Permit of Authorization to Construct an On-Site Sewage Facility Permit Valid For One Year From Date Issued

Permit Number: 118436

GW Septic Designs

On-Site Sewage Facility Application and Design

RE- Septic Design 540 Irene Dr. Canyon Lake, TX 78133

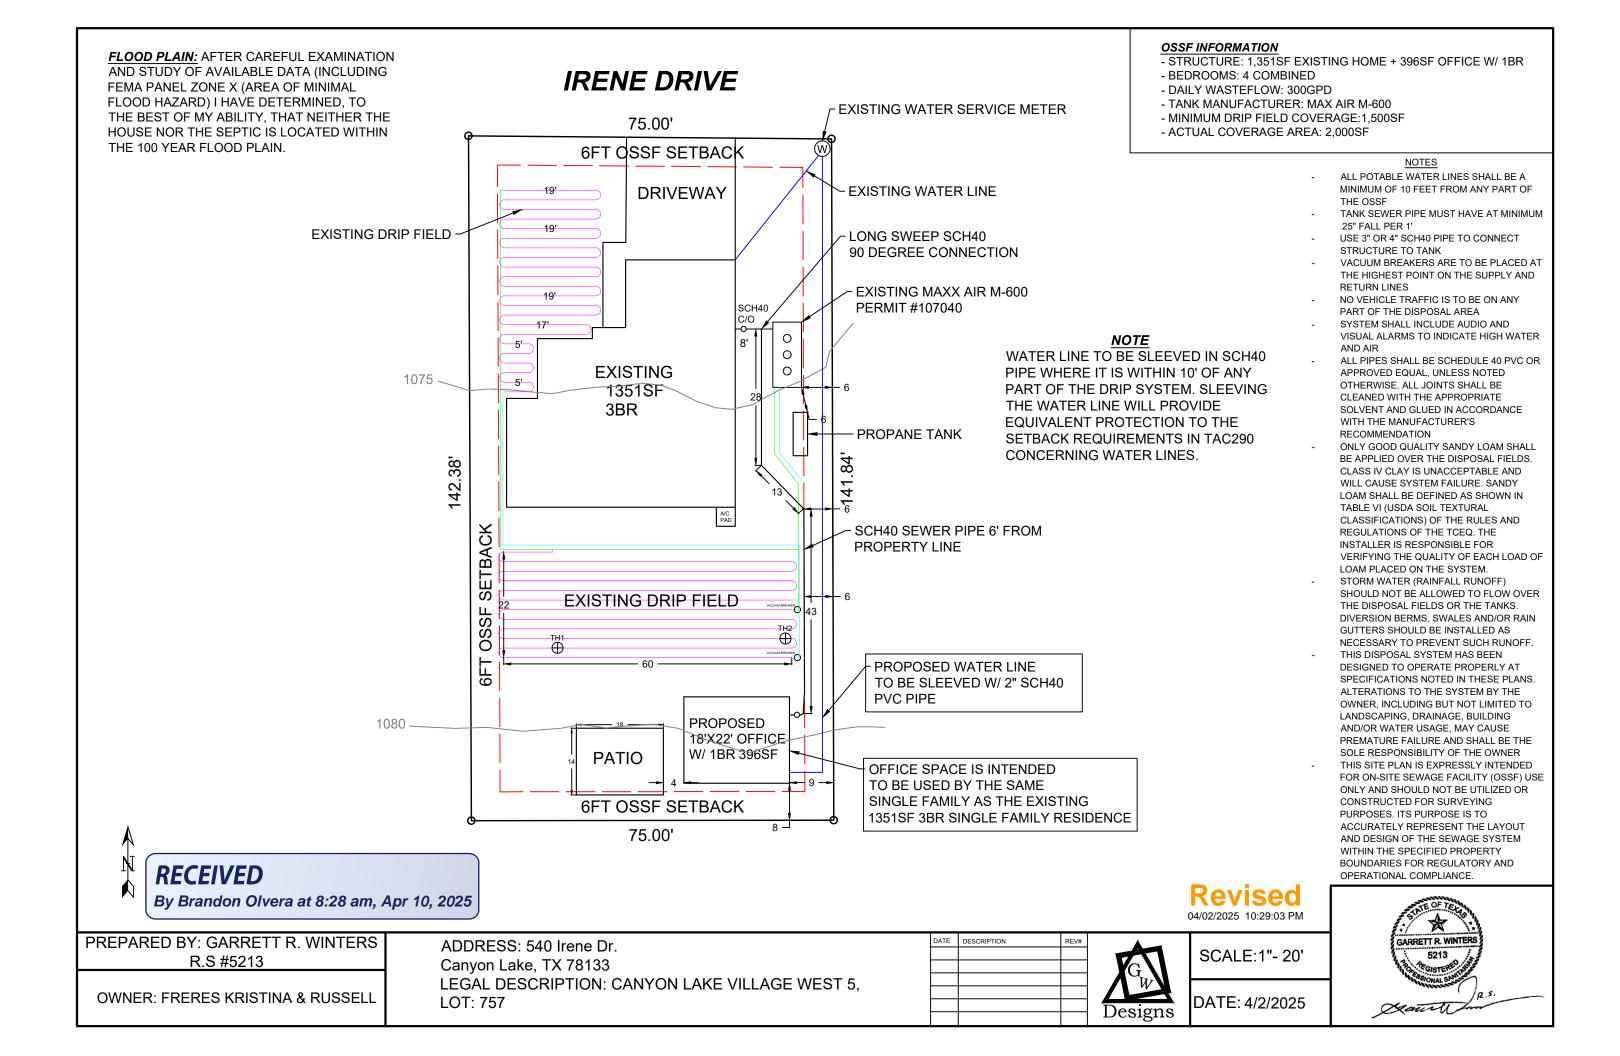
I am requesting a variance for a water line that is within 10ft of the OSSF drip field/Sewer pipe, and supply/return lines. The variance is being requested due to lack of space on this particular lot, equivalent protection will be maintained by sleeving the water line with 2" SCH 40 PVC pipe where it is within 10' of the OSSF components. I hereby request a variance to chapter 285 Table X & 290.44 (e)(8). In my professional opinion this variance will not pose a threat to the environment or public health.

The proximity of drip field to waterline needs to be in the form of a variance request. The notation on the design mentions the drip system in compliance with Chapter 290,

a. 285.91(10) Table X. There is also a 10 ft separation distance from sewer pipes with water tight joints and waterlines.
